CITY PLAN COMMISSION STAFF REPORT

November 15, 2022

1500 Meadow Lake Parkway

- 8.1 Development Plan case #CD-CPC-2022-00173
- 8.2 Area Plan Amendment case #CD-CPC-2022-00191

General Layout

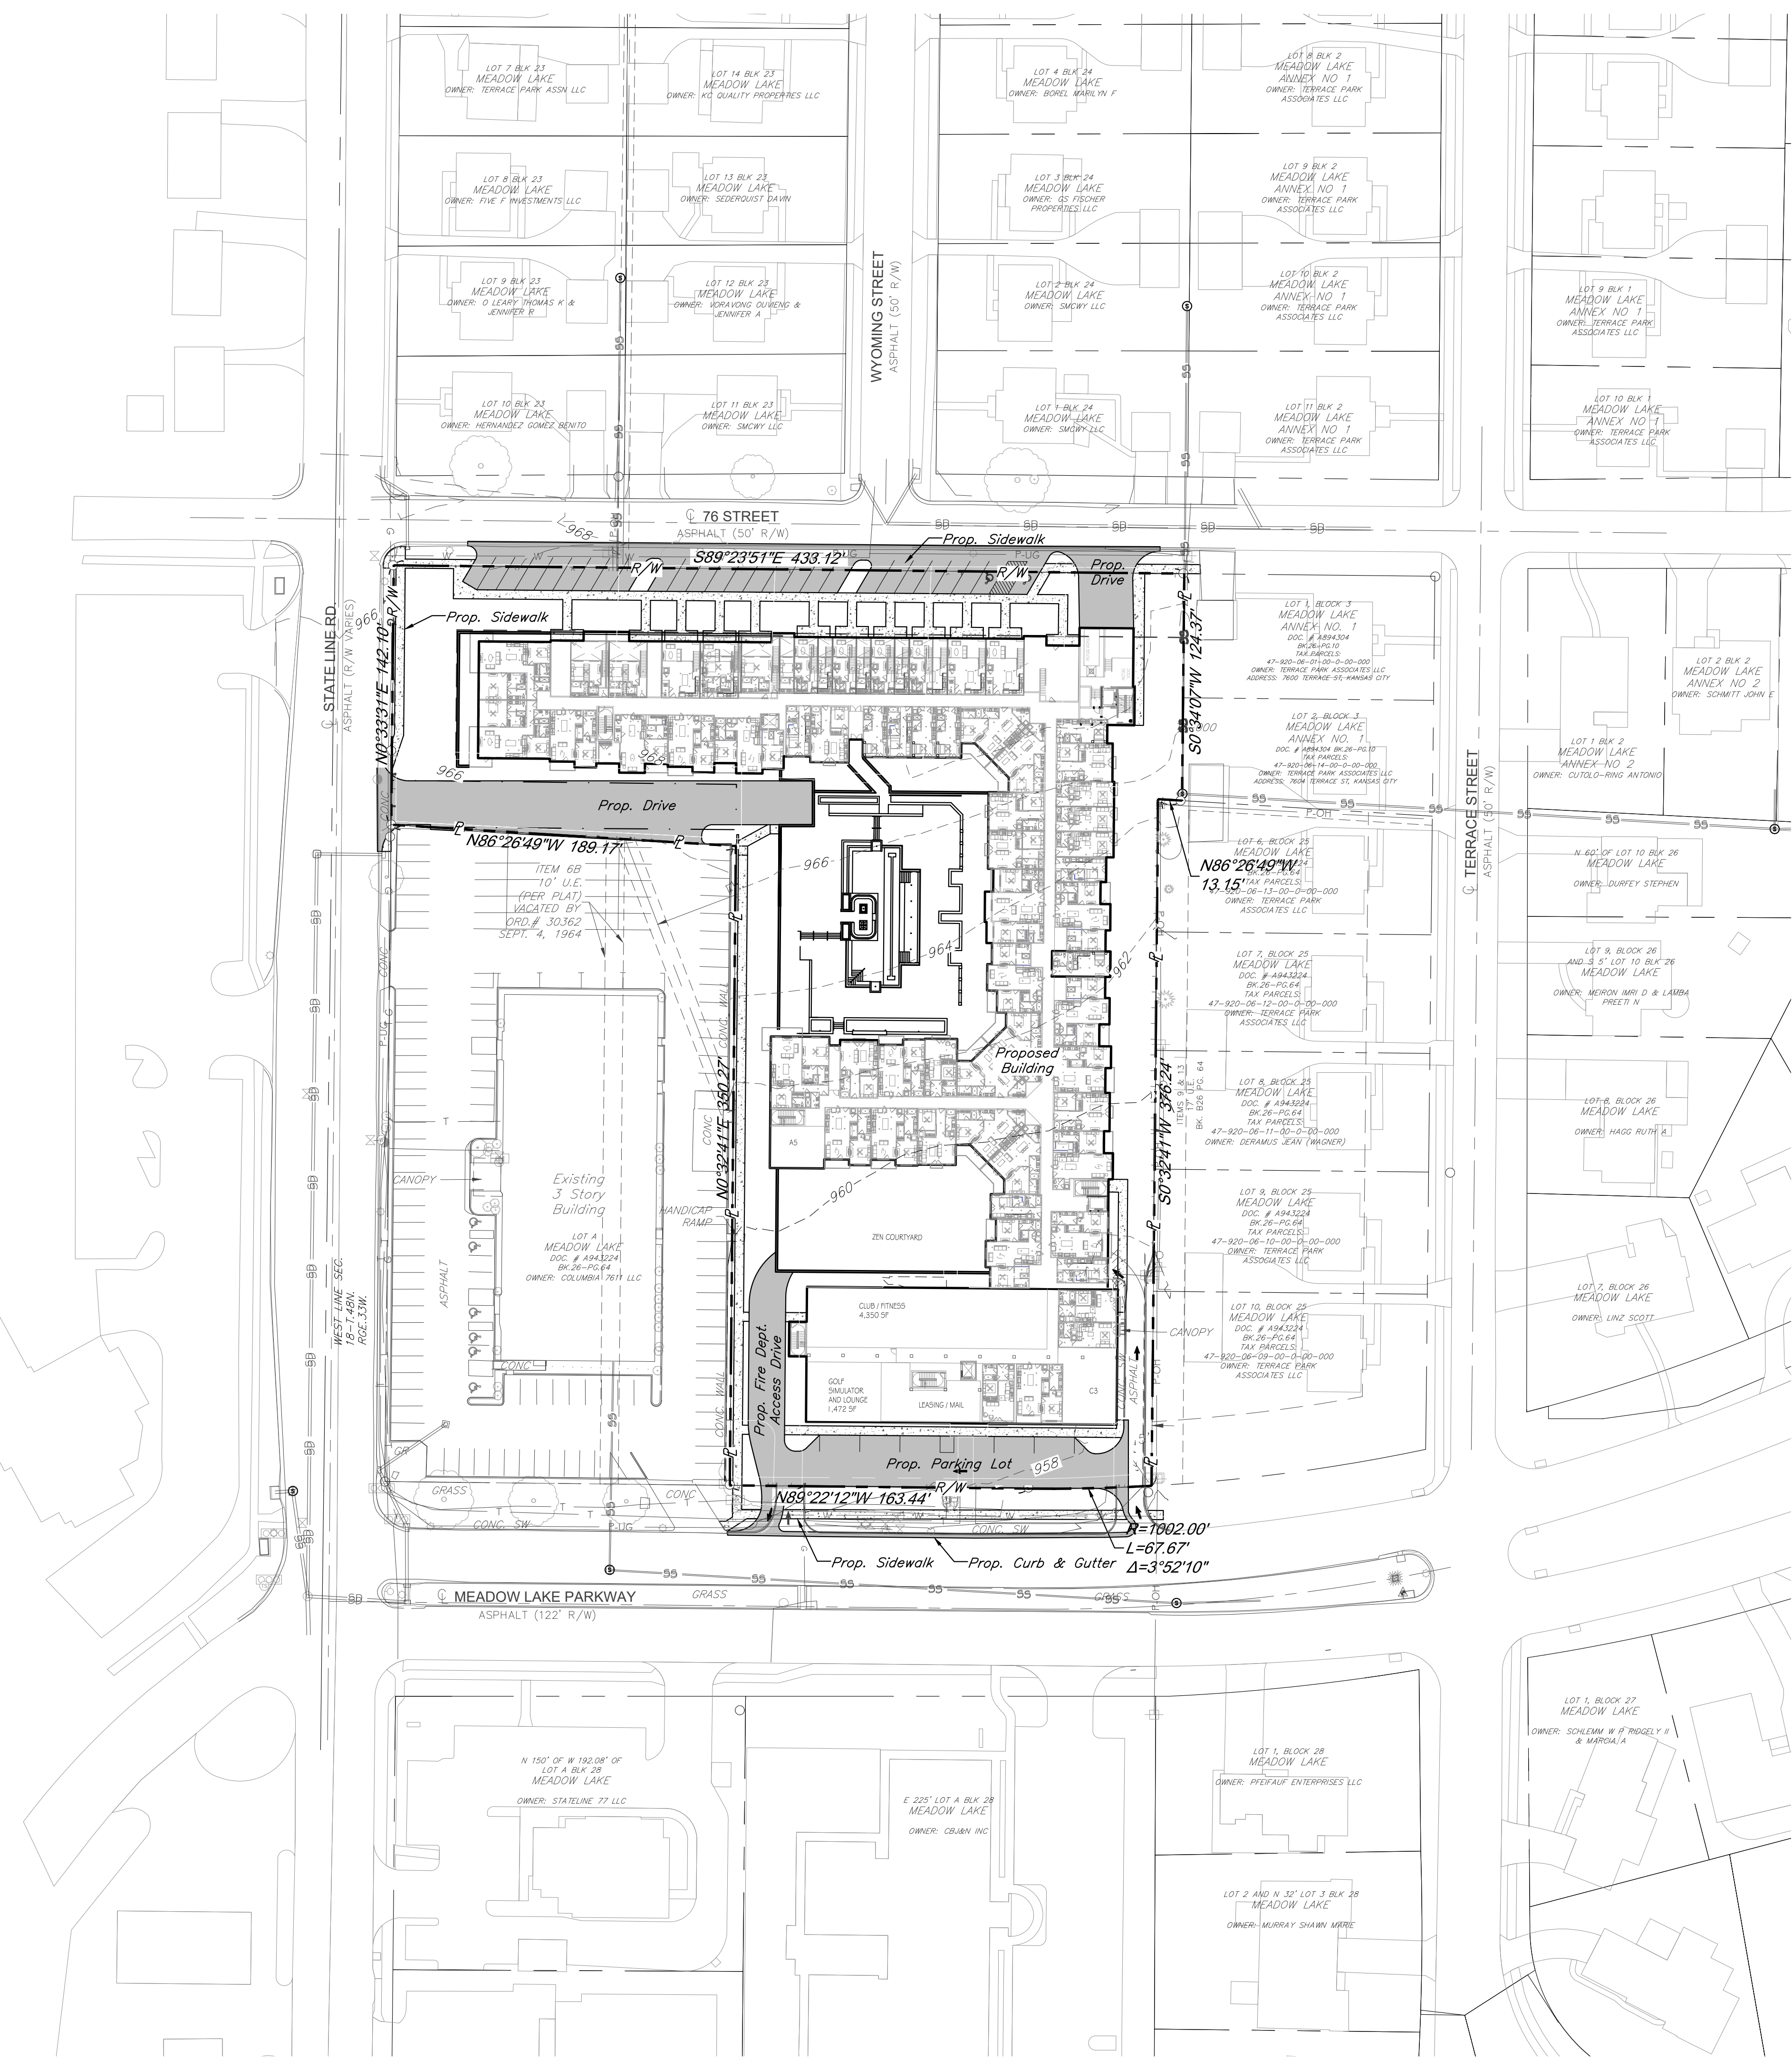
5. Should a waiver be granted through the Transportation and Development Committee on November 14, 2022 regarding the reverse entry parking spaces along the north of the lot, the applicant shall submit revised plans showing updated angles for the proposed parking spaces prior to ordinance request.

Utility Plan

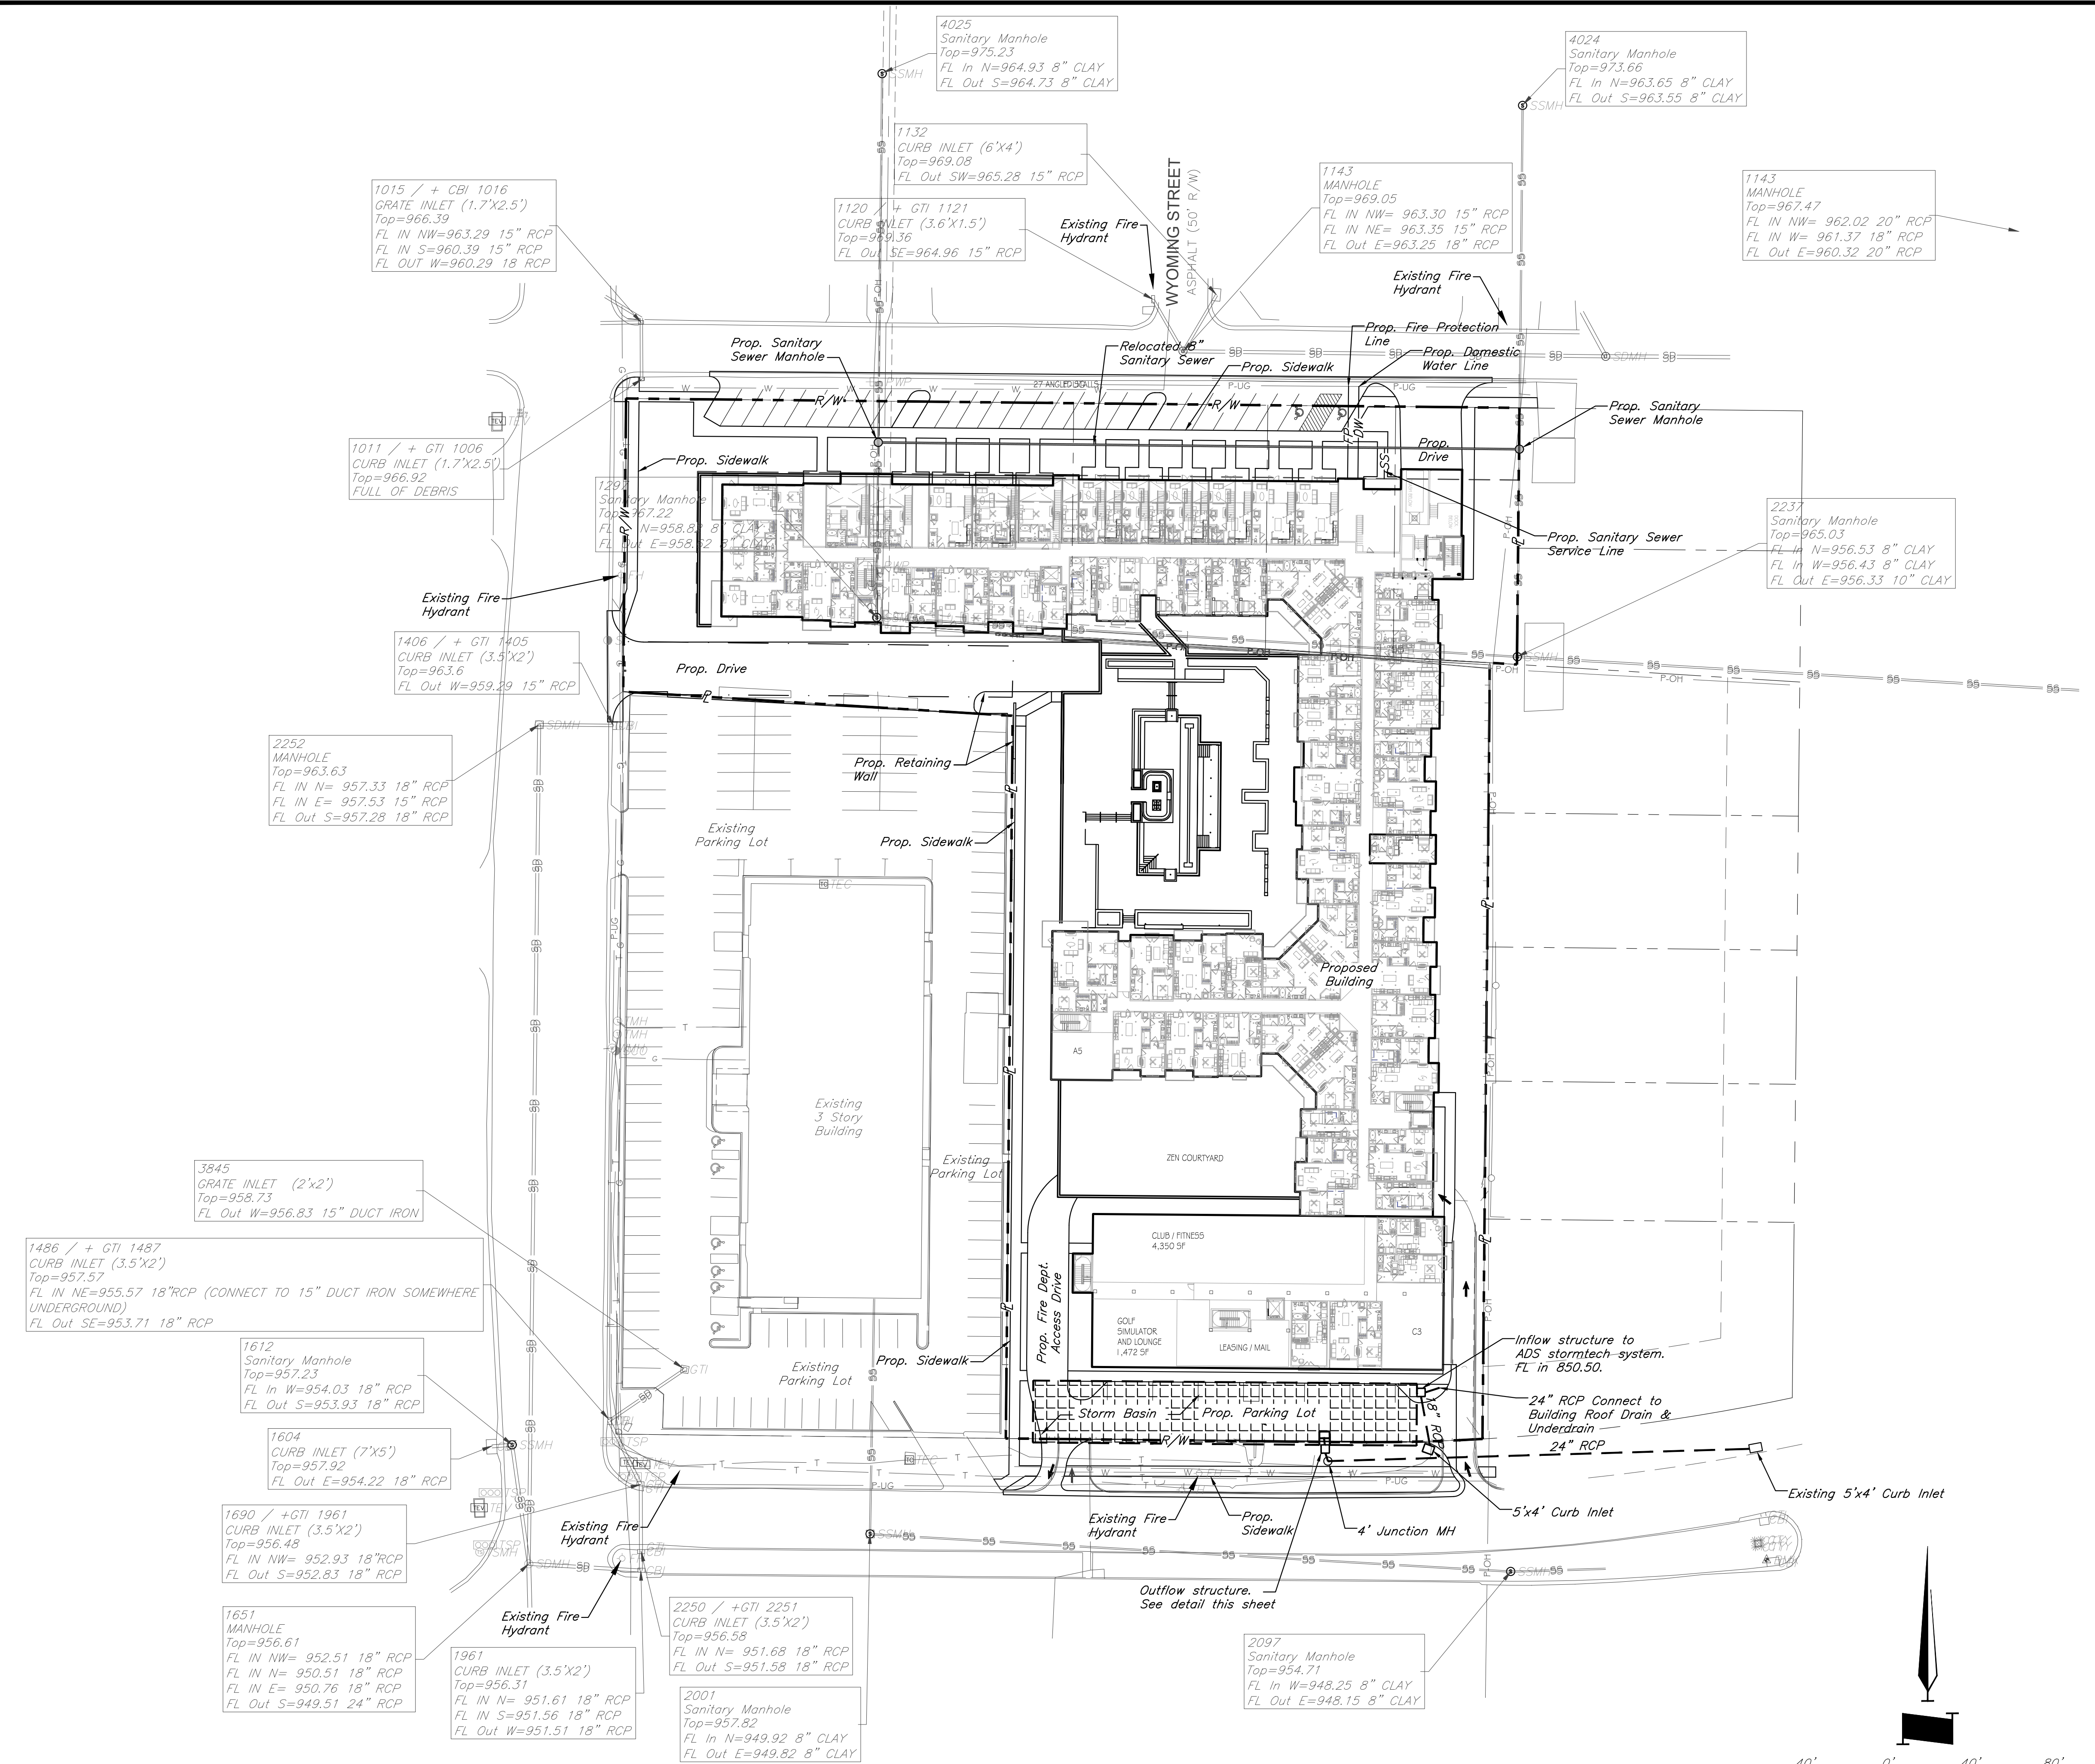
9. The developer must petition for the vacation of sanitary sewer easement as shown on the development plan and relocate sewers as required by the Departments of Water Services, the Land Development Division, and Development Services prior to recording of the final plat.

13. The developer provide acceptable easement and secure permits to relocated sanitary sewers out from under proposed buildings and structures, etc., while continuing to ensure individual service is provided to all proposed lots as required by Land Development Division prior to recording the plat or issuance of a building permit, whichever occurs first.
